**RE: Russell Biomass Project - Air Permit**

The purpose of this letter is to comment on the air quality permit for the Russell Biomass plant. The FEIR's analysis of air quality impacts resulting from the plant and associated activities appear to be seriously deficient. I request that DEP consider the issues raised in this letter in relation to the Russell Biomass air quality permit and require a full response by the applicant where appropriate, prior to issuance of permits. I further request that MassDEP respond to the questions and requests for more information from DEP itself presented in this letter. Please notify me as to your decision on how to proceed in response to this request. I hope that a month will provide sufficient time, therefore I request a response by August 11, 2008.

Figure 1. Comparison of the topography of Westfield AFB site (left) and Town of Russell (right). The grey circle represents the approximate position of Westover AFB; the black arrow points to site of proposed Russell Biomass plant.

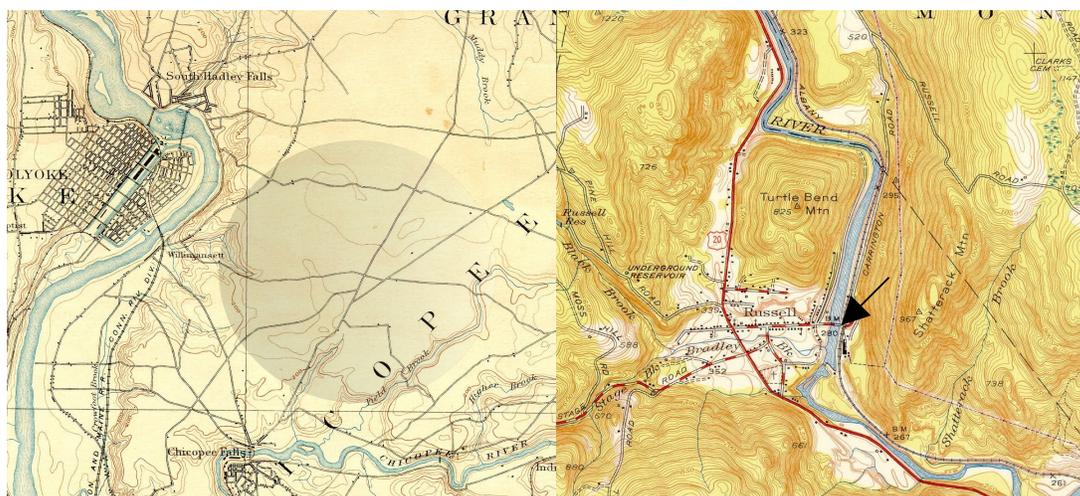
Results of the air quality modeling and claims by the proponent that plant emissions will not worsen air quality in the town of Russell should be greeted with the utmost skepticism. To begin with, the FEIR states that AERMOD model was run to simulate plant emissions effects on Russell using data from the Westover Air Force Base because "Meteorological data from Westover AFB are representative of the site due to similarities in topography, namely both locations are in north-south oriented river valleys and both have high terrain immediately to the east."<sup>1</sup> This is a ludicrous statement, as demonstrated below in the historic maps presented in Figure 1. Westover AFB is located on a broad plain; rising terrain is distant. Russell is located in a narrow river valley, closely surrounded by steep slopes. With regard to particulates, the choice of Anderson Road at

Westover AFB to illustrate background  $PM_{2.5}$  concentrations very likely under-represents actual  $PM_{2.5}$  concentrations in Russell, where mountainous terrain traps air pollution. Further, Russell is a rural area and is likely to have more wood-burning stoves that contribute to local air pollution than do the suburban neighborhoods around Westover.

Modeling results can only be as good as the data and assumptions that lie behind the model, and even the proponents' own modeling results, which show the highest deposition rates of particulates occurring on the side of Shatterack Mountain, indicate that plant emissions will flatten out and be trapped by the topography around the town. Along with air quality impacts to the town, deposition impacts of toxins, ammonia, and heavy metals to the terrain and forests around the plant are likely to be severe, as shown by the maps presented in the FEIR. Such deposition rates are likely to result in forest blight in the state-owned Tekoa Mountain Wildlife Management Area, impacting fauna and flora alike. MassDEP should consult with a credible third-party reviewer on the modeling data and make public the agency's response as to why the terrain and meteorological assumptions in the modeling are considered adequate.
